ADDENDUM NO. 1
TO
PROCUREMENT AND CONTRACTING REQUIREMENTS
FOR
NineStar CR200 Sewer – Division I
FOR
NINESTAR CONNECT
Issue Date: October 25th, 2023

The following, as additions to and modifications in the Bidding Requirements and Contract Documents, will be included in, and become a part of the **NineStar CR200 Sewer – Division I**. This Addendum forms a part of the Contract Documents. Bidders are, therefore, instructed to take the following into account in rendering any Bid for this work. Acknowledge receipt of this Addendum in the space provided on the Bid Form.

E203

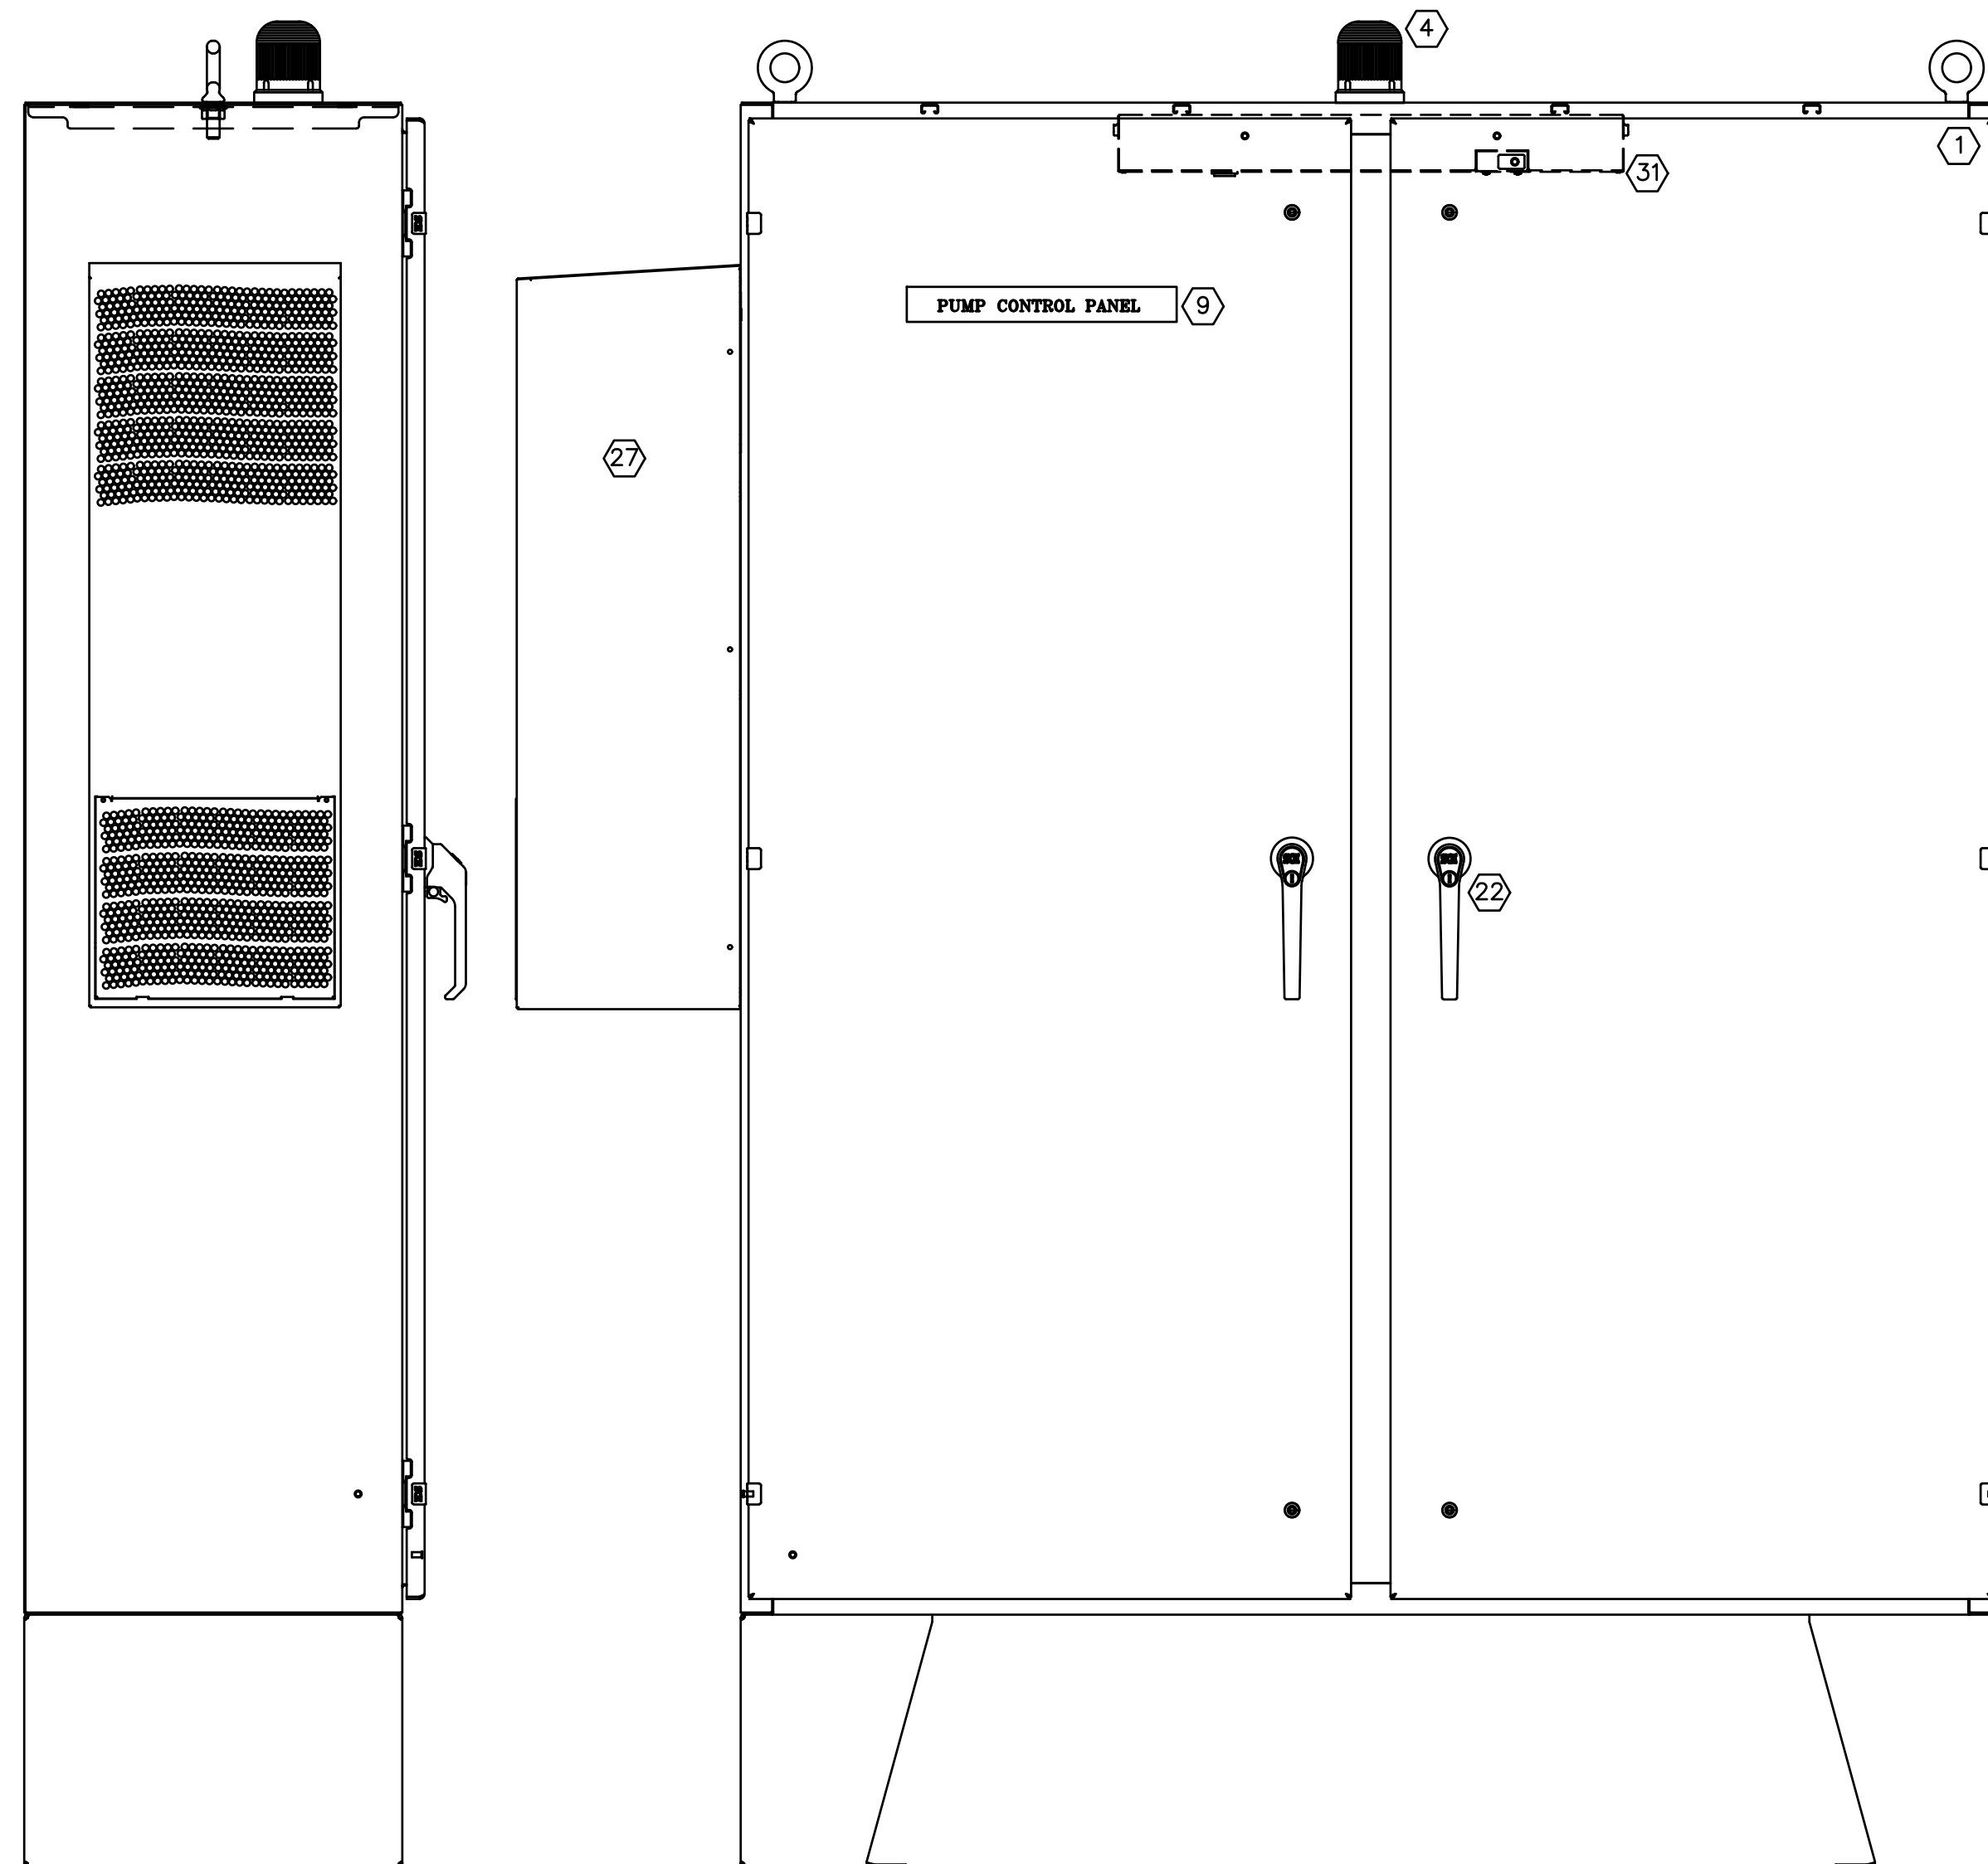
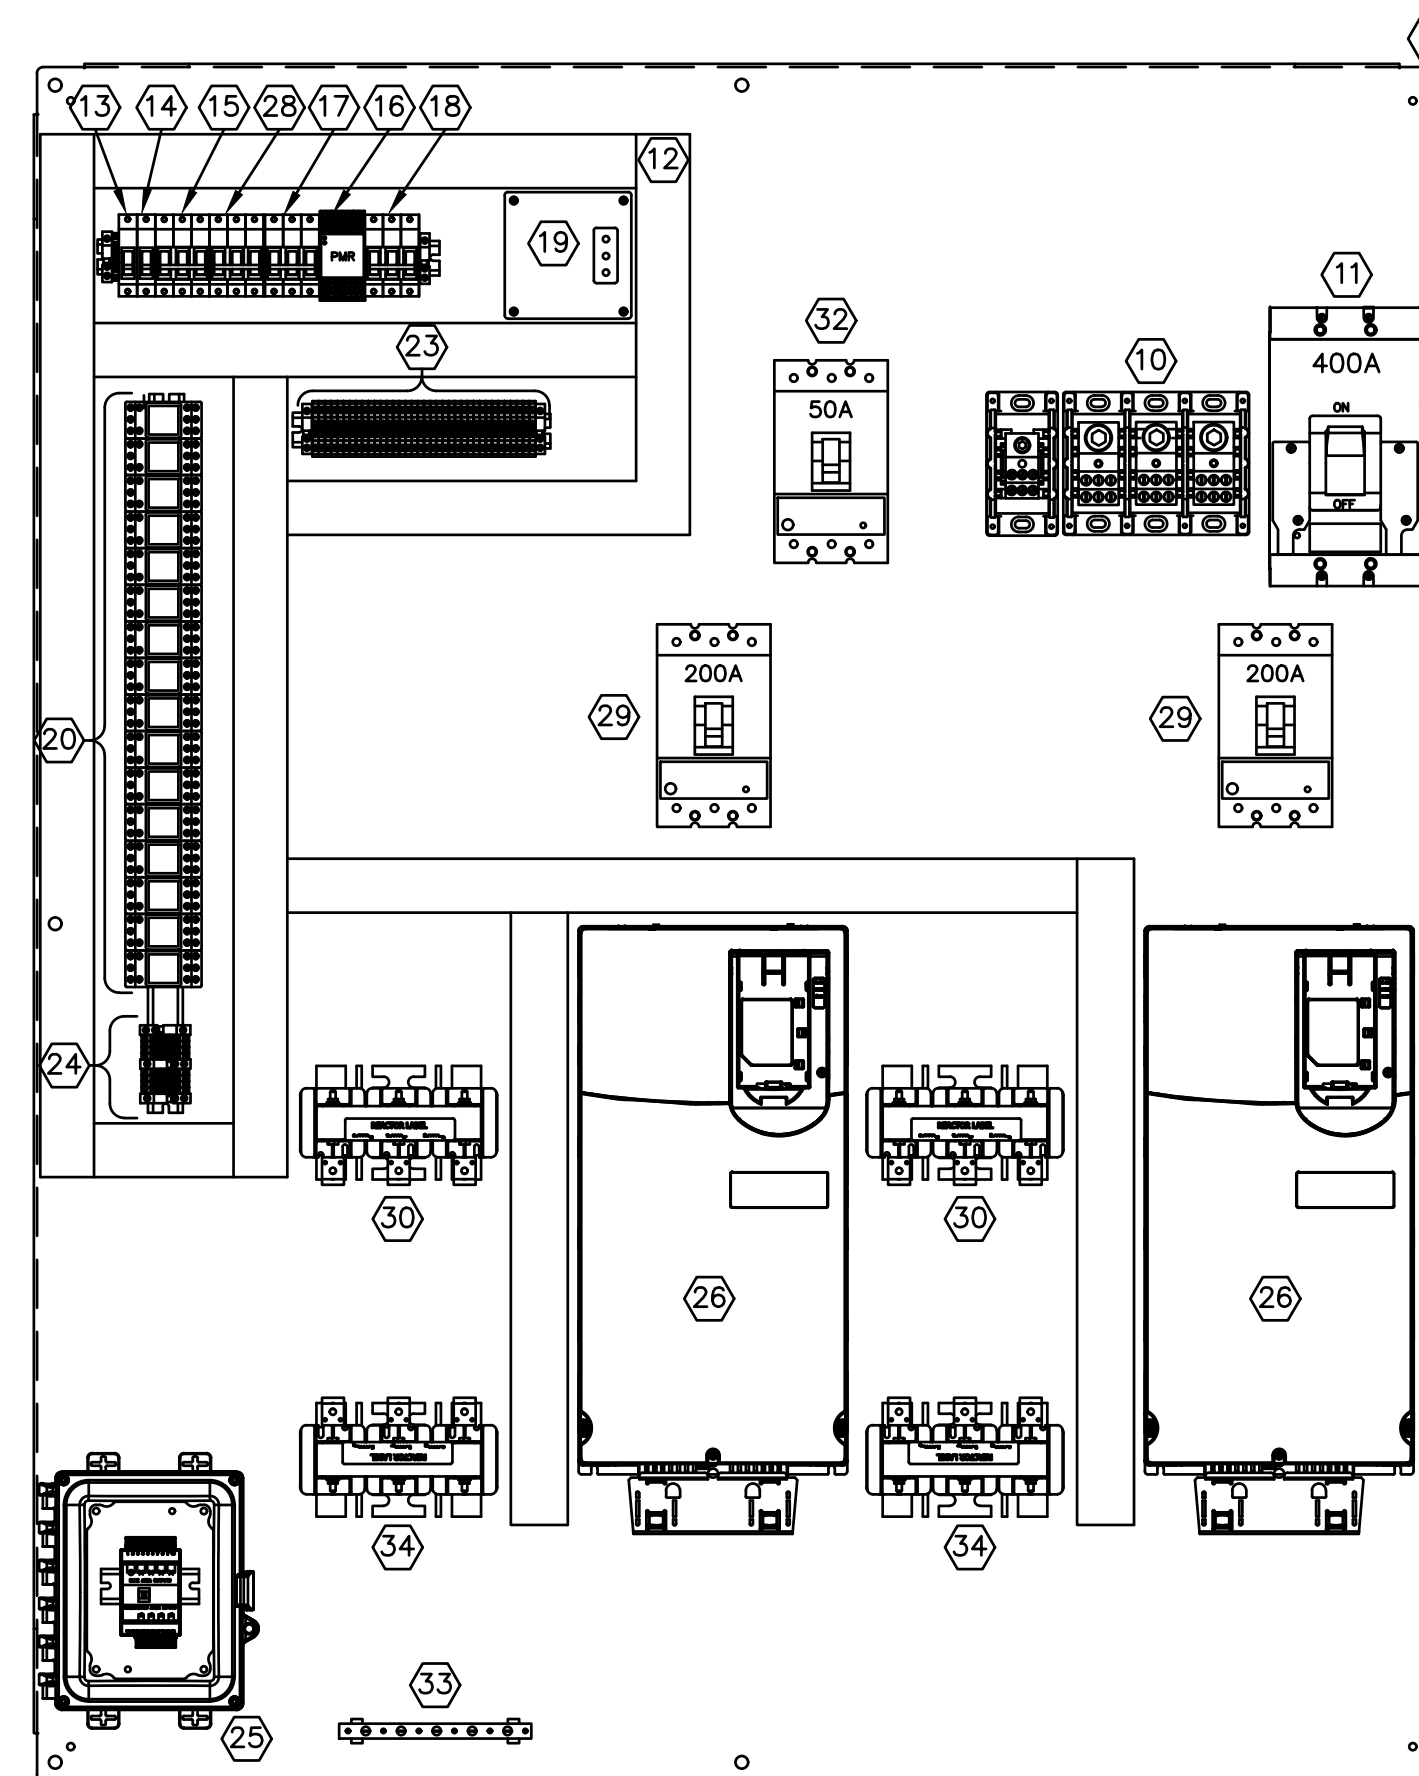
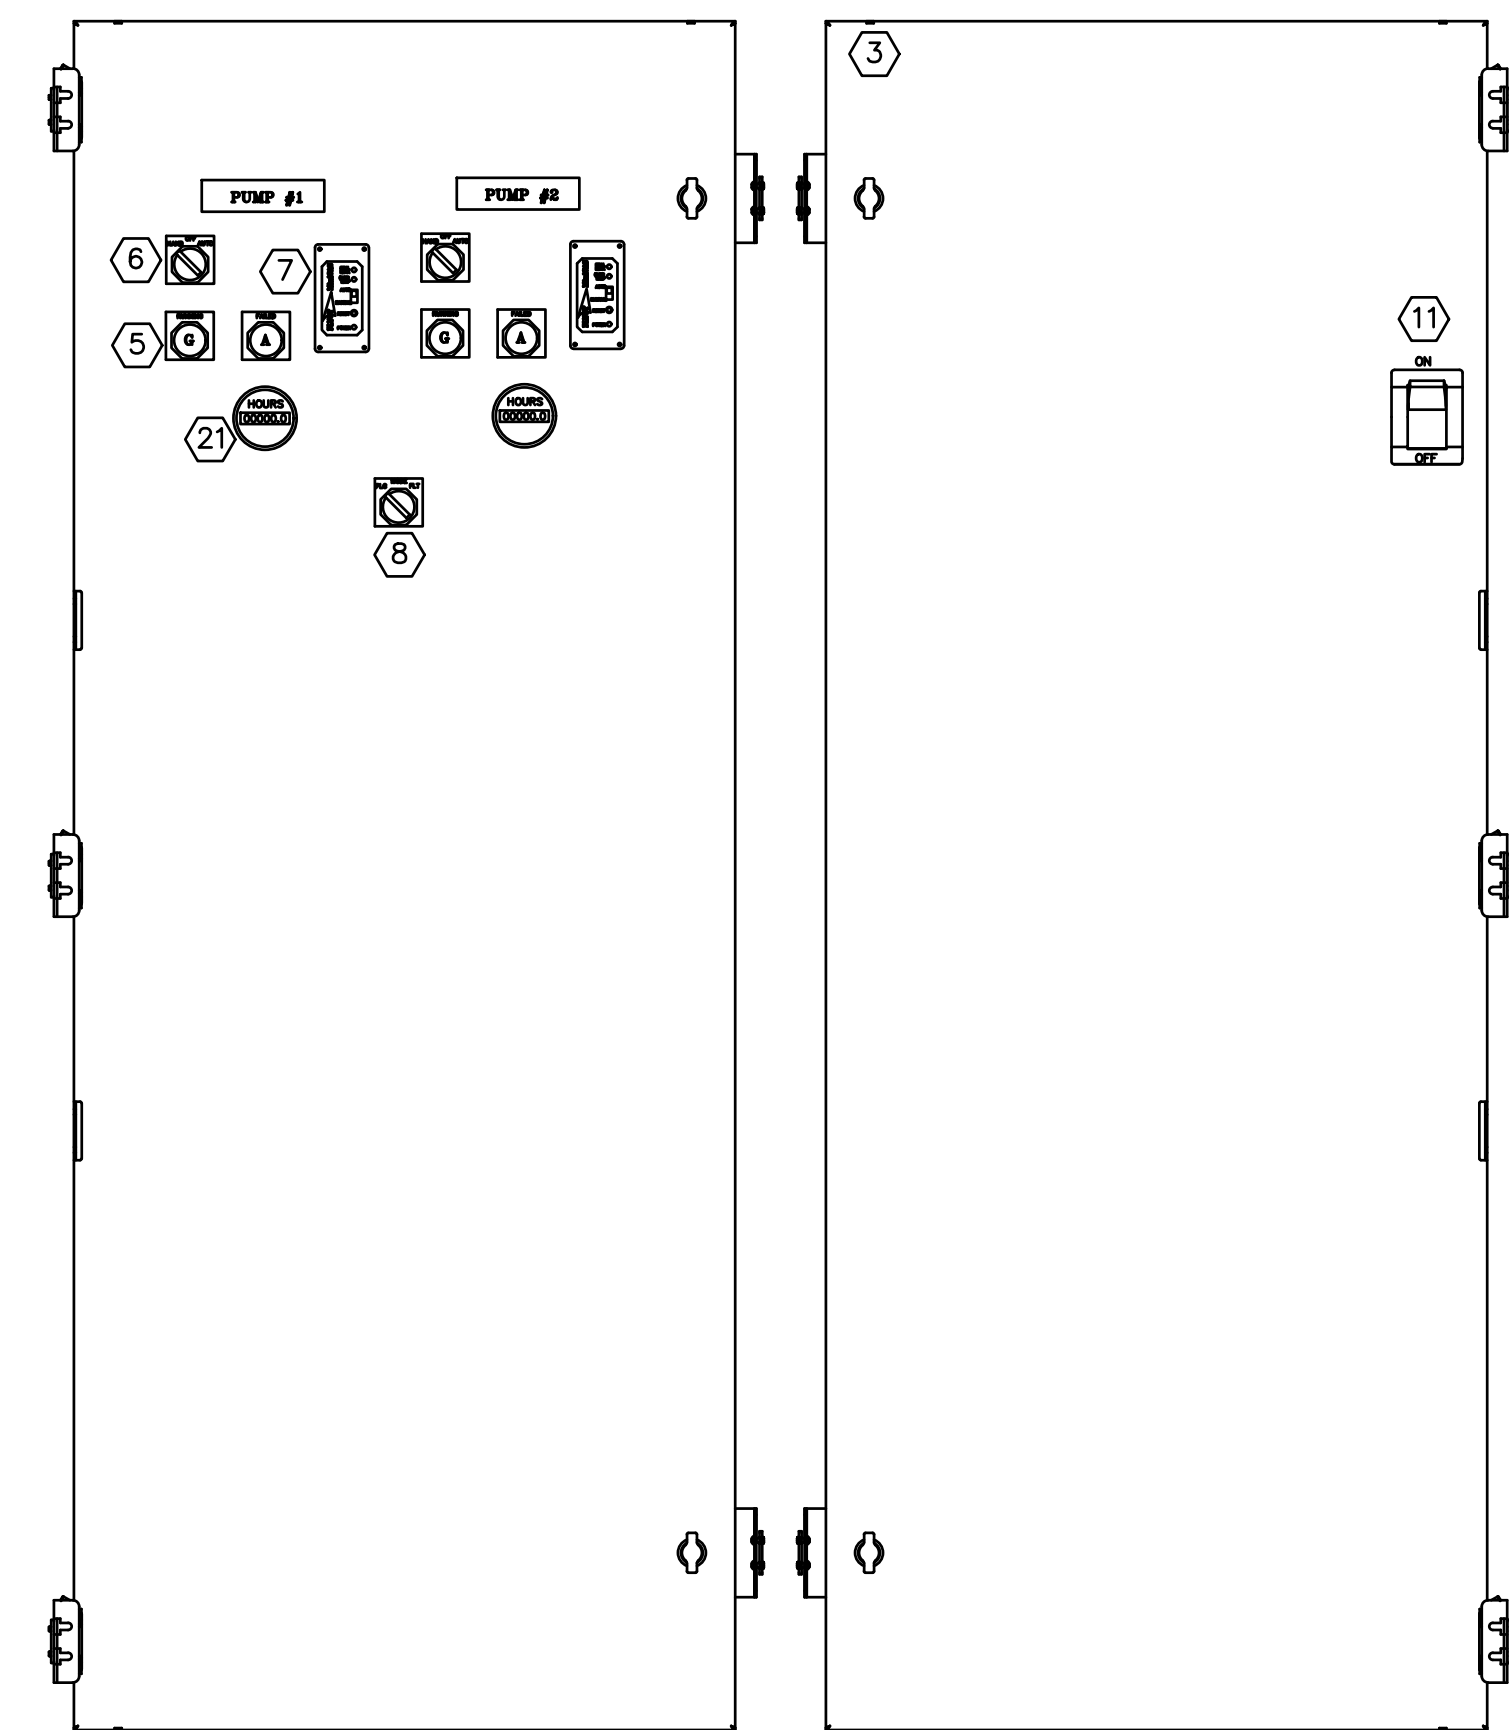
- g. Sheet E202 – Boulders Lift Station Electrical Details (Site detail modified for generator addition, coupling in vented channel removed.)
 - h. Sheet E203 – Boulders Pump Control Panel Layout Details (Added note about AC/Unit Heater.)
